IDAP REPORT

Property:	59 Oxford Road STRATHFIELD Lot 21 DP 2338 DA2021.206
Proposal:	Demolition of the existing dwelling house and ancillary structures and construction of a new two storey dwelling house, in ground swimming pool and outbuilding.
Applicant:	SWA Group (Steve Wu)
Owner:	J Huang
Date of lodgement:	18 August 2021
Notification period:	30 August 2021 to 13 September 2021
Submissions received:	Nil
Assessment officer:	G I Choice
Estimated cost of works:	\$1,415,000.00
Zoning:	R2-Low Density Residential - SLEP 2012
Heritage:	No
Flood affected:	Yes
RECOMMENDATION OF OFFICER:	APPROVAL

ELEVATION - NORTH 1:100

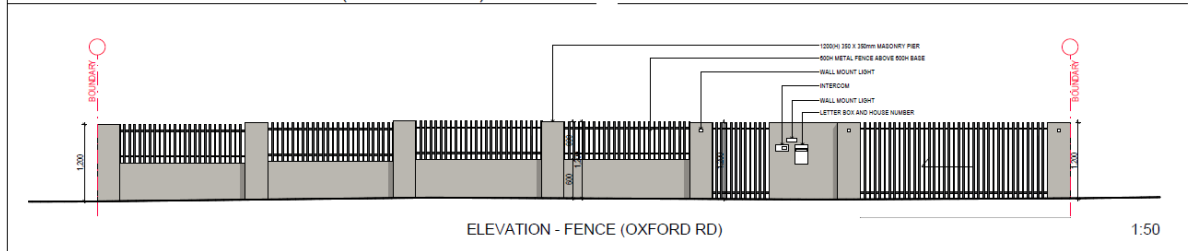
The proposed large rear first floor void is considered acceptable given plans have been amended to reduce the height of the alfresco roof and column feature to a single-storey structure which has substantially reduced the visual bulk of side elevations. Further, the orientation of the subject site indicates the void will not result in excessive overshadowing to adjoining properties.

The proposed first floor void windows are considered an inappropriate size and pose privacy impacts to the adjoining rear yard of 5 Heyde Avenue. A condition is imposed requiring the windows to be reduced to a minimum sill height of 1.7m above the finished floor level or have fixed, obscure glazing in any part of the window less than 1.7m above the floor level.
